Access Compliance Report

Public Rights-of-Way

(Curb Ramps)

Intersection ID: 13196	Main Street: ELIZABETH_AV	Cross Street: N_LONG_ST	Location: E
ADA ID: 935FEE4C3D84	Ramp Type: BlendTrans1	Initial Pass/Fail: Fail	Overall Compliance: No
			Severity Score: 21.25

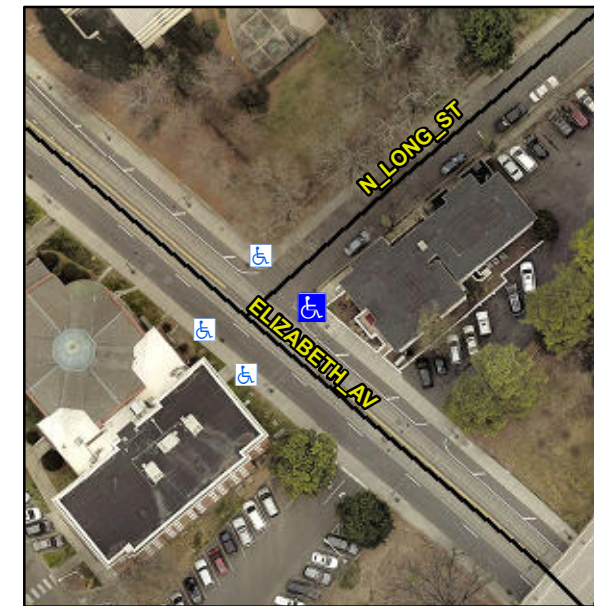
Not Found, R304.5.1, R304.5.3

Compliance	Description	Data	Compliance	Description	Data
N/A	Ramp Length (in)	83.0	Yes	BlendTrans Slope (%)	2.0
No	Ramp Width (in)	45.0	No	BlendTrans XSlope (%)	5.7
N/A	Flare Type LT	N/A	N/A	Flare Type RT	N/A
N/A	Flare Slope LT (%)	N/A	N/A	Flare Slope RT (%)	N/A
N/A	Flare Traversable LT?	N/A	N/A	Flare Traversable RT?	N/A
N/A	Landing Length (in)	N/A	N/A	DWS Provided?	N/A
N/A	Landing Width (in)	N/A	N/A	DWS Contrast?	N/A
N/A	Landing Slope (%)	N/A	N/A	DWS Length (in)	N/A
N/A	Landing X Slope (%)	N/A	N/A	DWS Full Width?	N/A
N/A	Landing Curb? (Y/N)	N/A	N/A	DWS Offset (in)	N/A
N/A	Shared Landing?	N/A			
N/A	Gutter Ponding?	N/A	N/A	Gutter Slope (%)	N/A
N/A	Gutter Lip Ht (in)	N/A	N/A	Gutter X Slope (%)	N/A
N/A	Painted X Walk1?	No	N/A	Painted X Walk2?	No
	X Walk 1 Direction	To NW		X Walk 2 Direction	To SW
	X Walk 1 Width (in)	N/A		X Walk 2 Width (in)	N/A
	X Walk 1 Slope (%)	3.5		X Walk 2 Slope (%)	2.5
	X Walk 1 X Slope (%)	2.7		X Walk 2 X Slope (%)	2.9

Remove & Replace Curb Ramp With Two New Directional Ramps or Equivalent.
